DEPARTMENT OF COMMUNITY DEVELOPMENT SERVICES

m e m o r a n d u m

TO: The Urbana Historic Preservation Commission

SUBJECT: HP-2010-COA-03: Request for a Certificate of Appropriateness to replace six windows at 115 W. Main Street, R Rentals, applicant.

South elevation showing 5 windows proposed for replacement

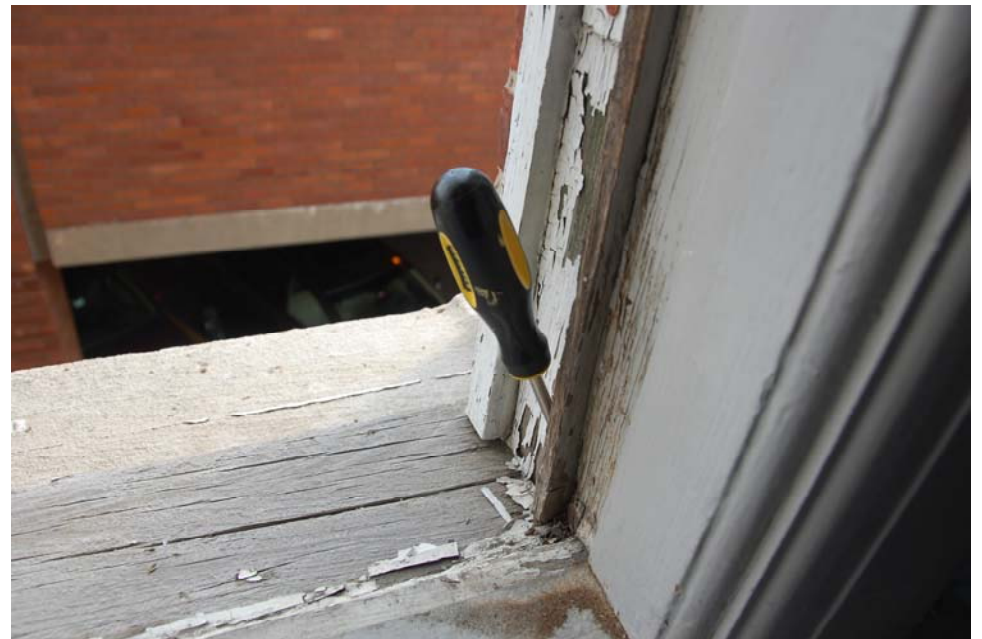
Rear elevation: The four windows that have been without the protection of storm windows are severely deteriorated and the wood does not have sufficient integrity to be repaired. Staff has worked with the applicant to find the most appropriate replacement windows and to have them installed in a manner that will not harm the integrity of the building. The replacement windows are the type approved by the Illinois Historic Preservation Agency on upper stories of commercial buildings for projects using the Federal historic tax credit. They will replicate the profile, architectural detailing, and installation of the existing windows as closely as possible (see drawings attached to application). The fifth window has been protected by a storm window and is not in the state of severe deterioration that the other windows are in. However, as all of the other windows on the rear elevation require replacement, it seems sensible to allow the applicant to replace this window as well. The replacement windows are double-paned and will not require storm windows on the exterior. If the applicant is only allowed to replace the four deteriorated windows on the rear elevation, the aesthetic of the one original window will be compromised by the exterior storm and the fact that it is the "odd one out."

Most of the bottom portions of the frame and sash are rotted

Bottom sill has been replaced with temporary board

Notice rot along left side and along bottom rail

Screwdriver sunk into wood frame showed wood rot

West elevation with window mix of half-moon tops and flat tops

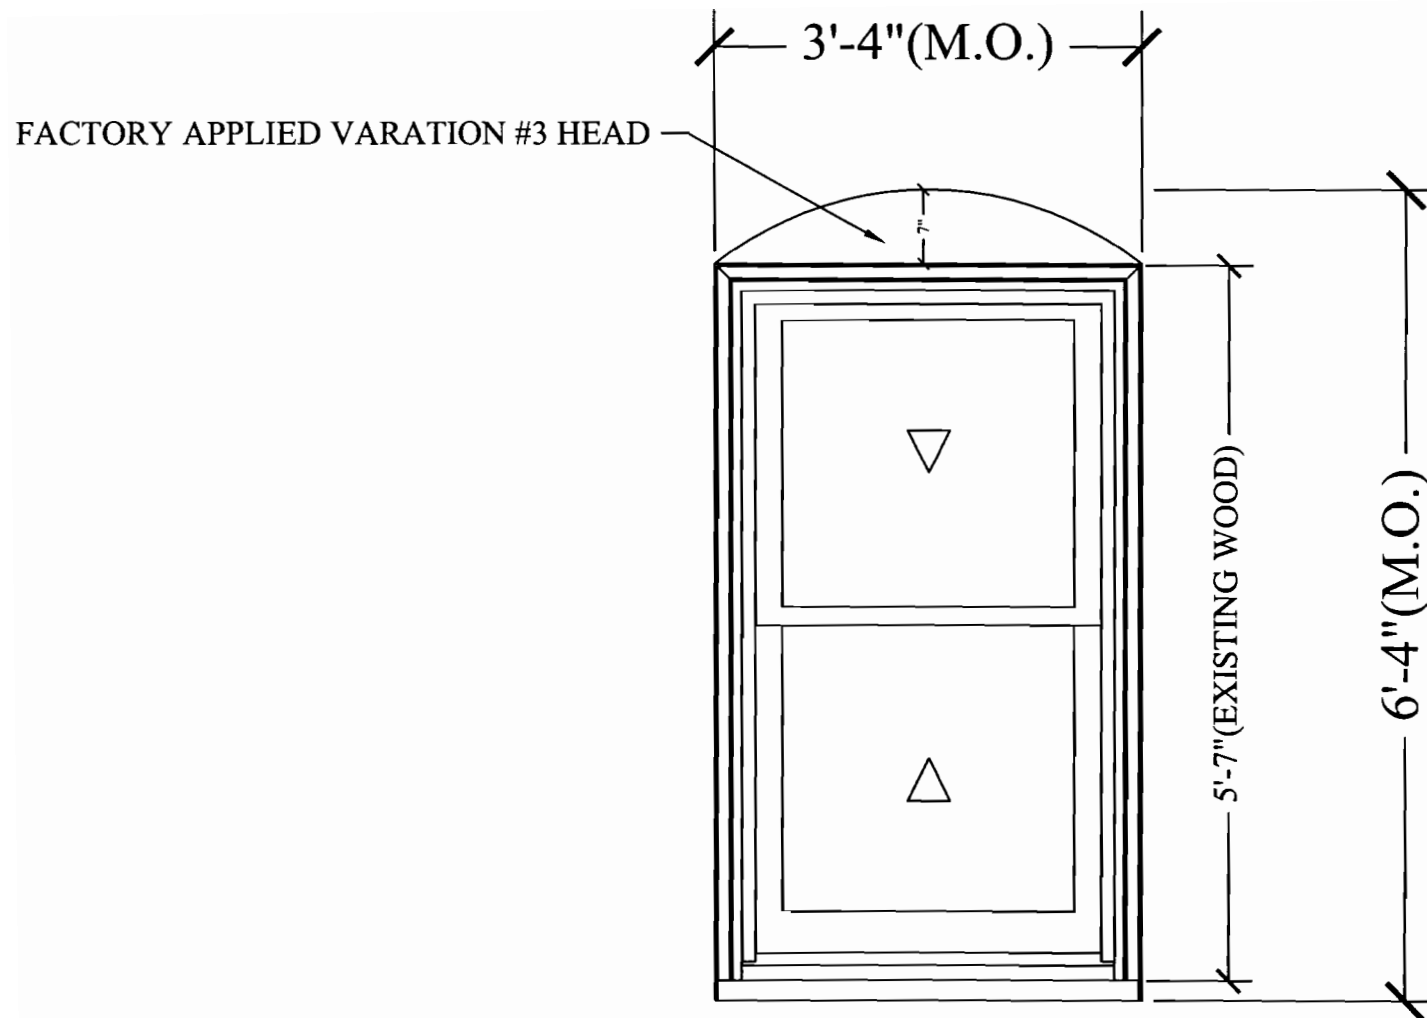
West elevation: Although the wood of this window is structurally sound, the building having shifted requires a slightly smaller window to fit in the opening. The existing framing in the window opening is not wide enough to accommodate the original window in that opening. As the applicant is having these replacement windows custom-made for the rear elevation, it is cost efficient for him to have a replacement made for this window at the same time. This window is visible from Main Street and Crane Alley, but as it is on the third story, it can only be seen from a sharp upward angle or from across Main Street.

Top corner of 3rd-floor window with out-of-square frame

Lower corner of 3rd-floor west window with out-of-square frame

HEAD DETAIL

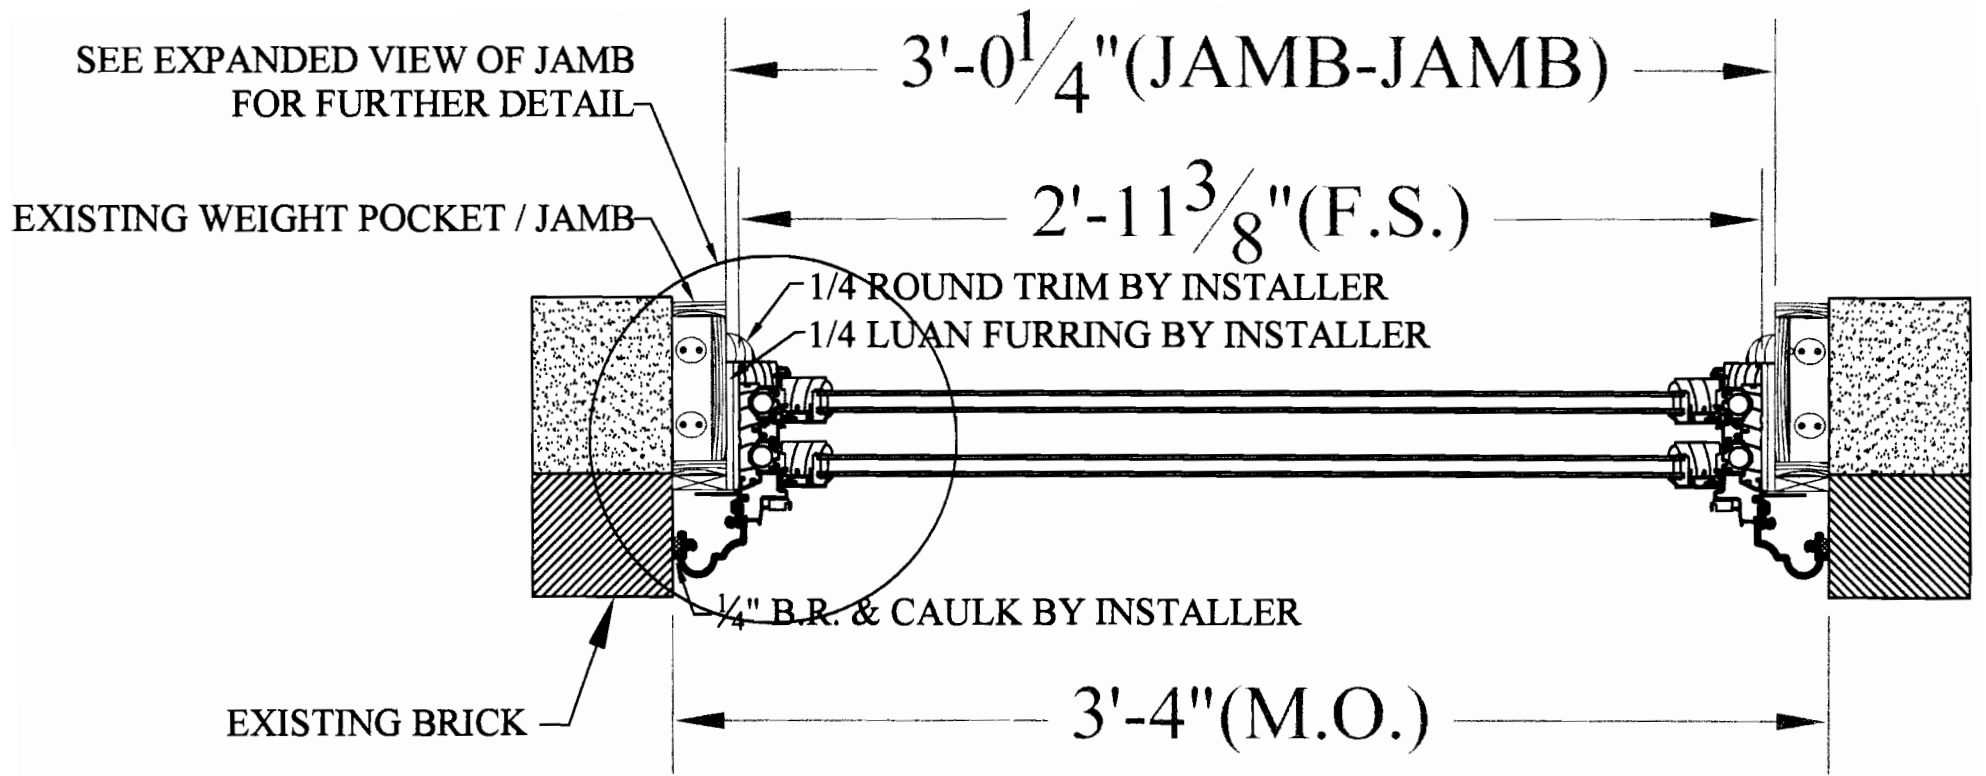
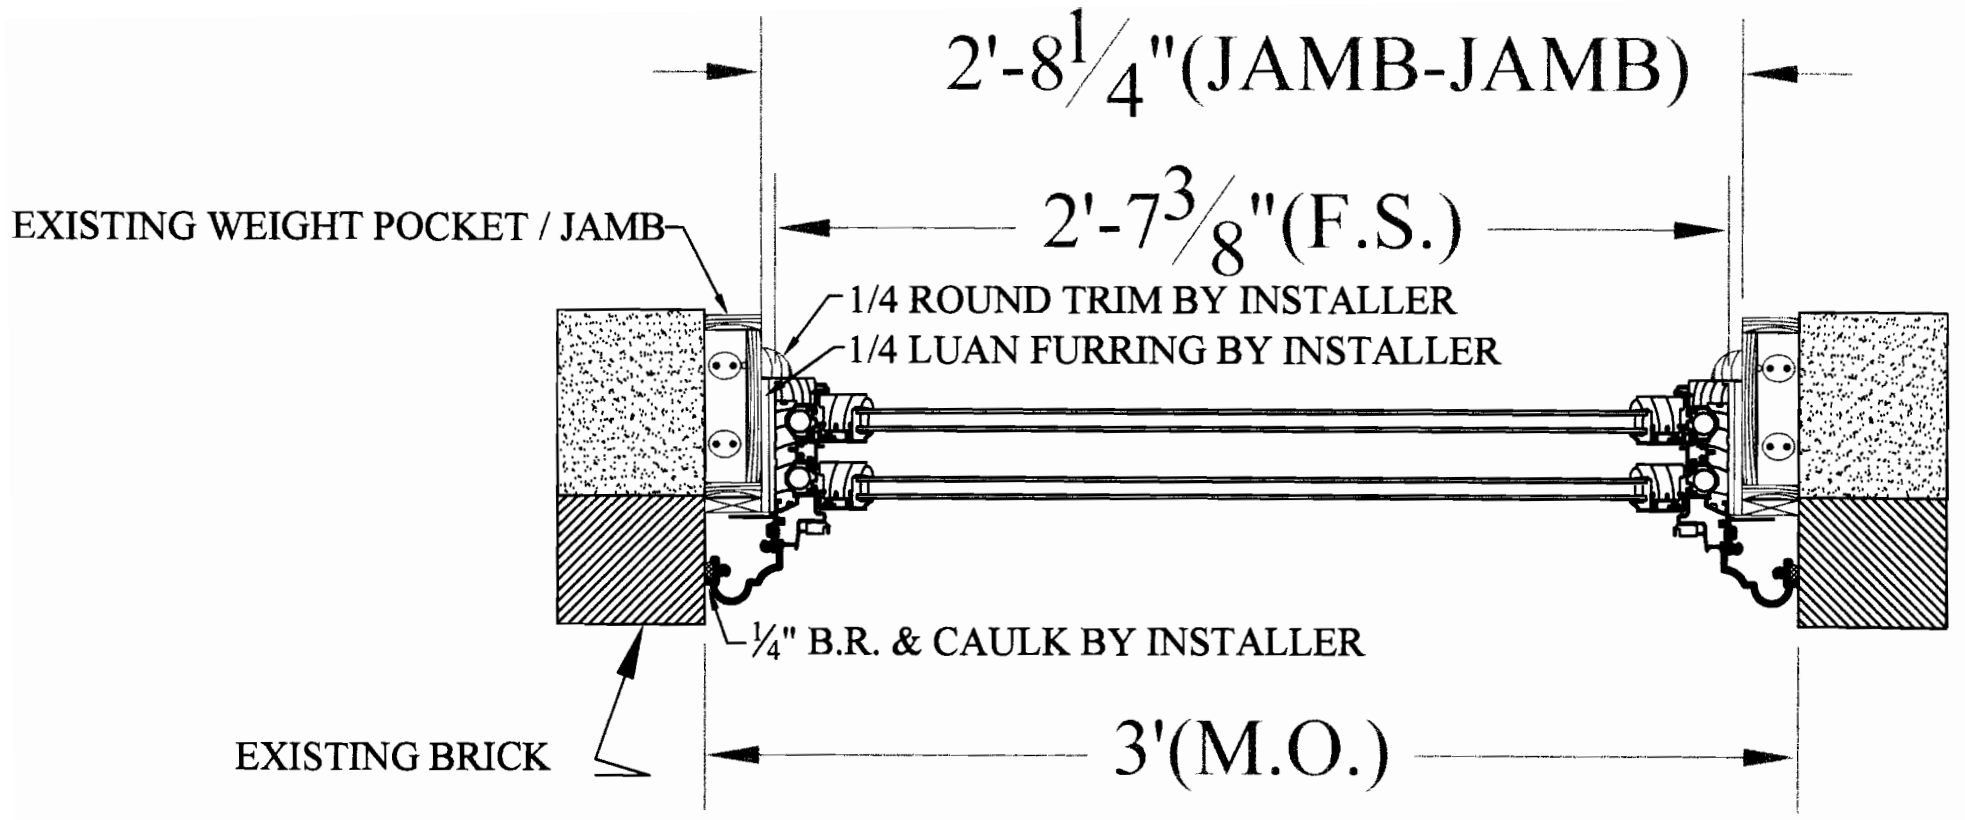
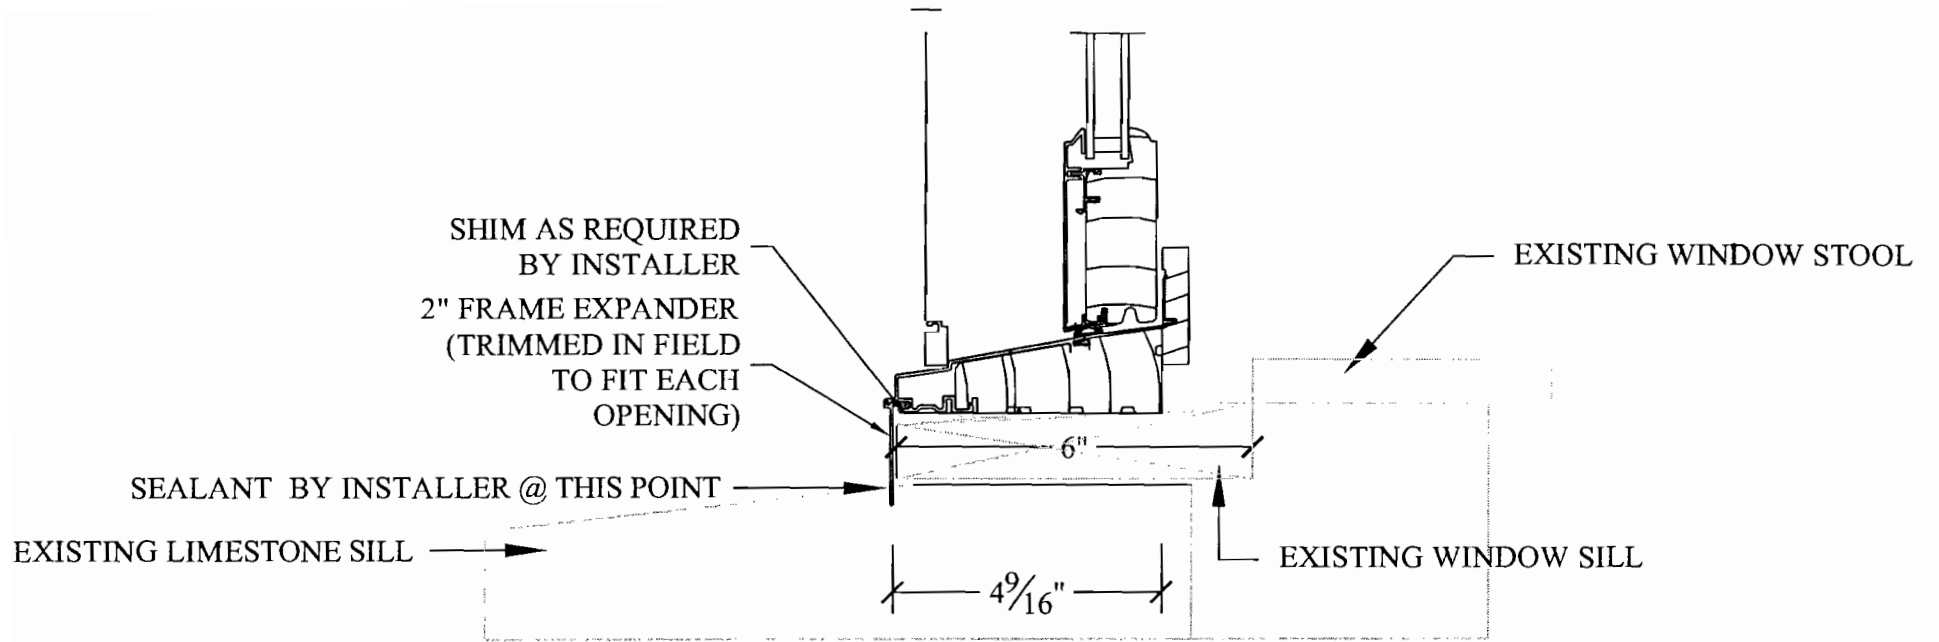
aluminum to provide protection to the wood. In addition to the importance of how the replacement windows are built is how they are installed. Replacement windows must be installed in a manner that replicates how they are currently installed. City staff has worked with the applicant to ensure that the installation will be compatible with the historic installation, particularly in two respects: 1) reveal: the reveal from the front face of the window framing to the front face of the building should mimic the existing reveal; and 2) the window should be installed directly on the limestone sill and not with the two-inch frame expander as shown in the plans.

1. The replacement windows will be built and installed in general conformance to the application as submitted.
2. The replacement windows will be installed with the reveal from front face of the window framing to the front face of the building to match the existing reveal.
3. The replacement windows will be installed without the two-inch frame expander as shown in the sill drawing unless it is necessary.
